## PRODUCT CHANGE NOTIFICATION

#PCN-DC-BH29-14

### Description of Change:

Previous Product	New Product
<p data-bbox="207 514 308 546"><u>Female</u></p> 	<p data-bbox="873 504 974 535"><u>Female</u></p> 
<p data-bbox="207 987 276 1018"><u>Male</u></p> 	<p data-bbox="873 987 941 1018"><u>Male</u></p>

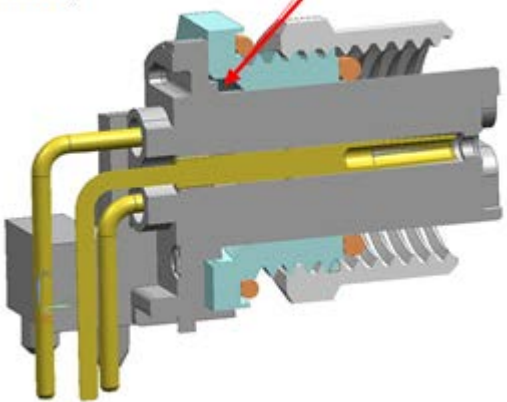
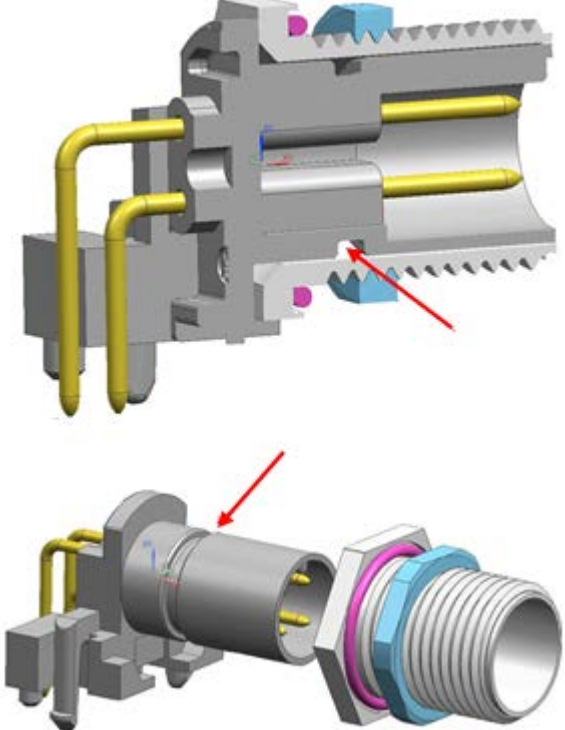
To improve the IP rating in the unlocked condition, the contact carrier for the male version will have a slot added for an optional O-ring. For the female version the flange on the back side of the contact carrier will include an additional O-Ring. On the housing for the female version the chamfer will be increased. All other technical details will be unchanged.
